Staff Report

Project Name: Modifications to previously approved storefront windows

Case Number: COA25-0001

Location: 2600 W. Main Street

Figure 5: Proposed elevation, Curtice St. side of 2600 W. Main St.

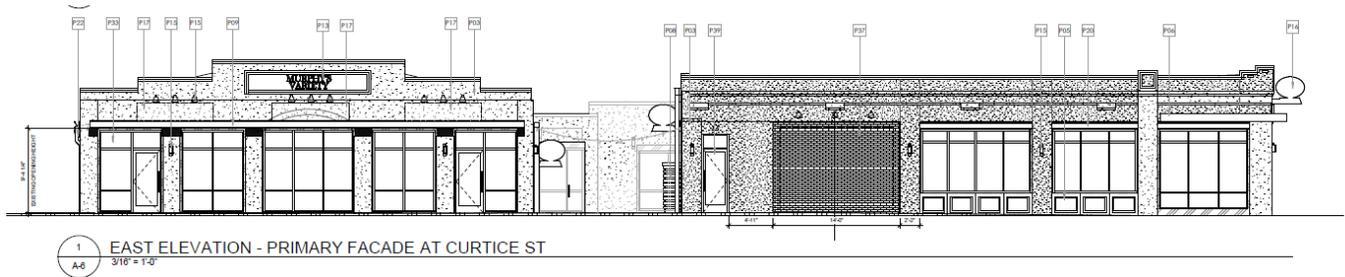
The proposed modification will infill one set of storefront windows with brick. The brick portion will be slightly inset and painted with a mural to create interest and a sense of identity for the tenant space.

Section 10-1-3.1.C.A of the ULUC allows for various treatments to minimize the amount of blank wall at the street level, as the requested removal is in response to an internal function (i.e. structural issues above-referenced). The mural is an approved blank wall treatment under Table 10-1-3.1.C Blank Wall Treatments of the ULUC. The brick portion of the façade is 14ft wide by 9ft-11 in. The top of the brick inset is in line with the other storefront windows on the elevation. Three, down cast lights are proposed to go above the mural. The second storefront to be removed included both windows and a door. The door will remain, but the surrounding windows will be removed. The door’s location is original to the building. A single downlit light will be placed above the door.

The proposed modifications will not destroy any historic materials that characterize the property. The inclusion of the brick inset negatively affects the rhythm and architectural features of the proposed storefronts along Curtice Street but seeks to mitigate that through the inclusion of the mural and utilizing the historic door opening. The mural will help provide a sense of identity, as well as, diminish the starkness of a blank wall along an activated street. This standard appears to be met.

Staff finds that the Certificate of Appropriateness for 2600 W. Main St. does meet all the approval criteria in the ULUC Section 10-9-8.1. Planning staff recommends approval, with the following condition(s) on HPC Resolution 02-2025:

- 1) The applicant shall provide a note on the final plan set that the mural design cannot be incorporated or implanted into the building in such a manner as to physically distort or destroy the building; and
- 2) The applicant shall provide a note on the final plan set acknowledging and agreeing to maintain and preserving the mural with periodic cleaning, repairs, and repainting as needed in order that the mural design remains in good and workmanlike condition.
